Attachment 4 - Wollongong Development Control Plan (DCP) 2009 Assessment

CHAPTER D13 – WOLLONGONG CITY CENTRE

Variation in relation to Clause 2.5 rear building setback to Level 6

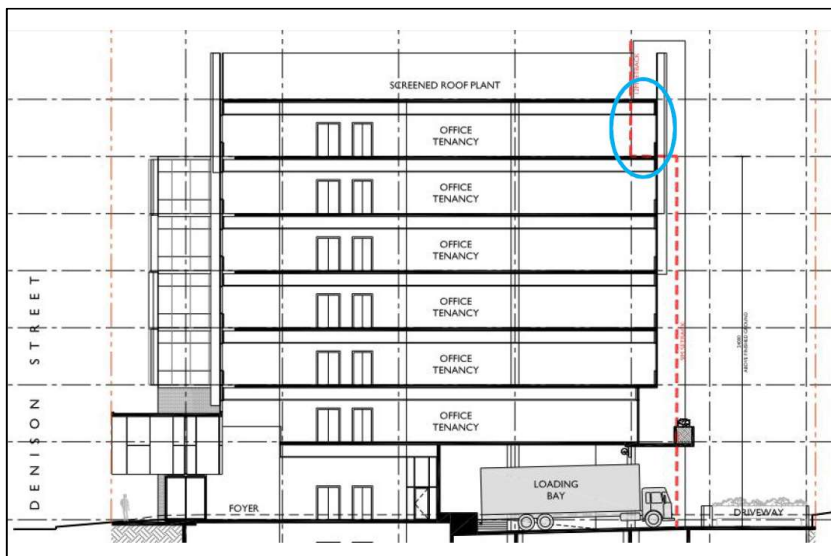
The control requires a 12m setback to Level 6 from the rear boundary of the site. The applicant has provided the following justification for the variation:-

In regard to the side setback above 24m in height, the proposed development provides a significantly greater setback than the required 6m on the northern elevation. However, the rear setback does not comply with the required 12m. The eastern (rear) elevation is articulated and the setback ranges from 9.4m to 11.4m.

This therefore equates to a shortfall of 2.6m-0.6m. Below is an extract of the section showing the noncompliance circled in blue:-

It is noted that the property adjoins the main southern railway line to the rear and as such a shortfall in the setback at the 6th level is considered negligible. Being a railway corridor there is no negative impact generated from the shortfall by way of solar access or privacy. Nor is there an additional loss of views from the noncompliance. In this regard the variation is considered acceptable.”

Planner Comment: the applicant’s justification is considered to be sufficient and the variation is supported. No adverse impacts will arise as a result of the reduced setback, on either the adjoining properties or internally within the site. The use proposed is not a sensitive noise receiver, the reduced setback will not compromise internal amenity for future building occupants.
